U. S. NUCLEAR REGULATORY COMMISSION  
OBSERVATION AUDIT REPORT OAR-99-05  
OF THE YUCCA MOUNTAIN QUALITY ASSURANCE DIVISION  
AUDIT M&O-ARP-99-12  
OF THE  
CIVILIAN RADIOACTIVE WASTE MANAGEMENT SYSTEM  
MANAGEMENT AND OPERATING CONTRACTOR

## **1.0 INTRODUCTION**

Figure 1. Technical Document Hierarchy for LA Design

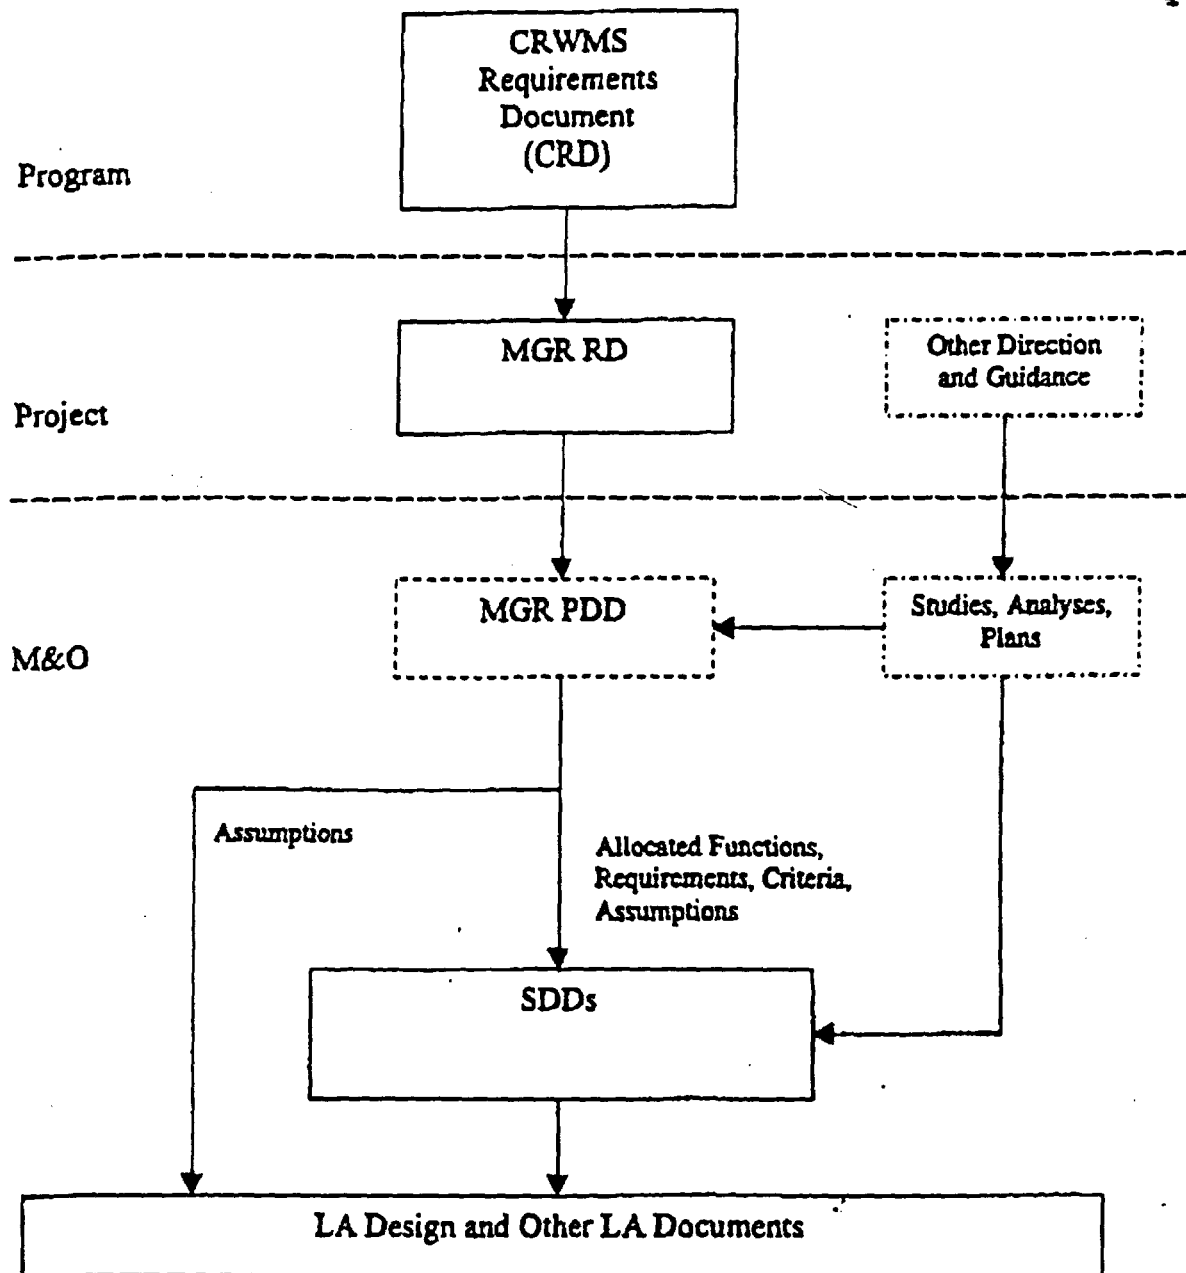
**Document Hierarchy:** In its effort to review the design control process, NRC staff have been raising the issue of DOE's (and M&O's) document hierarchy for quite some time. (See Issue Resolution Status Report of Repository Design Thermal-Mechanical Effects Key Technical Issue, section 5.1 and item 24 of its Appendix, September 1998.) As a follow up to that effort, the NRC technical observer requested the DOE audit team for the latest version of its document hierarchy that applies to its current activities. In response to this request, a copy of Figure 1- Technical Document Hierarchy for LA Design (a copy is attached to this report for ready reference) was provided to NRC via the NRC Site Representative's office. This proposed technical document hierarchy is expected to become effective when baseline document changes will be made to support a transition from VA to LA (i.e., when MGDS-RD, Rev.3 is baselined). The staff will continue to monitor DOE's progress in establishing a technical document hierarchy for its future design activities.
